re: Grading and Site Servicing Plan Review
Proposed Self Storage Development
75 Michael Cowpland Drive – Ottawa, Ontario

date: December 21, 2023

file: PG3798-MEMO.02 Revision 4

Figure 1 - Proposed Thickened Edge Slab Foundation Insulation Detail

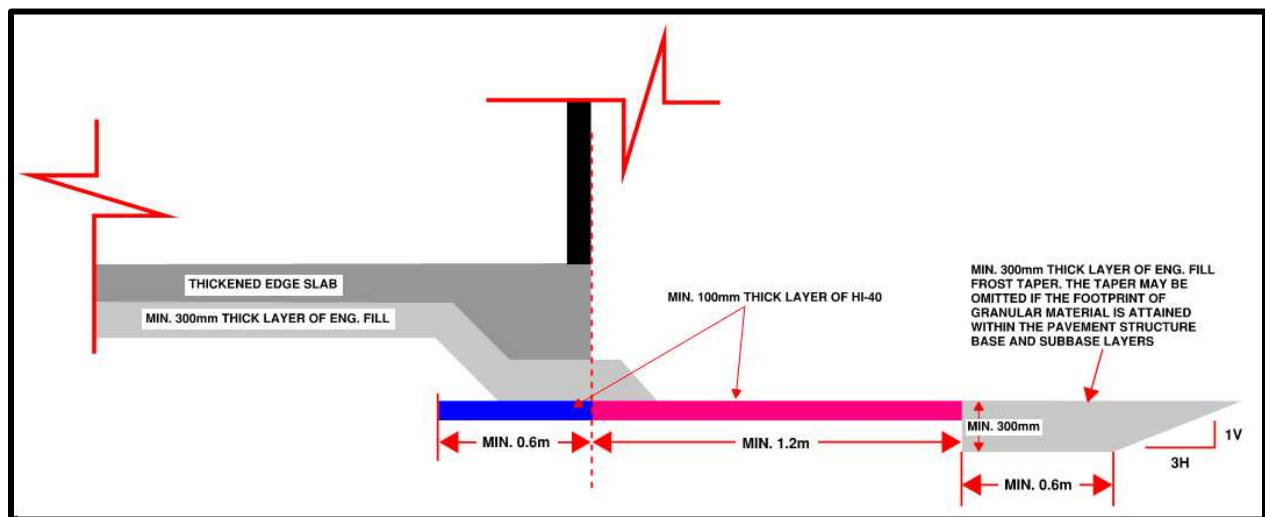
Upon discussions with the design team, the proposed thickened edge slabs are now proposed to be placed on vertical, concrete in-filled trenches where adjacent service pipes are proposed with the lateral support zone of the proposed structures. These trenches would lower the lateral support zone of the slabs below the service trenches ensuring that the proposed buildings are protected should future excavation be required for the proposed services for maintenance purposes.

Due to the anticipated depth and proximity of the proposed service pipes to the proposed thickened edge slab footprints, it is expected the lateral support zones for the proposed structures will be negatively impacted by the service installation works. Further, future maintenance that could be considered throughout the proposed service alignments would require trenches that would impact the proposed buildings lateral support zones. Based on this, it is recommended to lower the lateral support zones for thickened edge footings located adjacent to impacting service alignments. This may be accomplished by sub-excavating a near-vertical trench located directly below the overlying footing footprint and in-filled with minimum 17 MPa lean-concrete.

It is recommended the near-vertical trenches extend a minimum of 150 mm horizontally beyond the overlying footing footprint. Based on our review, the lean-concrete trench detail has been incorporated satisfactorily into the above-noted site servicing plans. The recommended perimeter thickened-edge slab foundation insulation detail is depicted below for the proposed storage structures and has been incorporated satisfactorily in the above-noted site servicing plans. The placement of the lean-concrete trench and rigid insulation should be reviewed and approved by Paterson personnel at the time of construction.
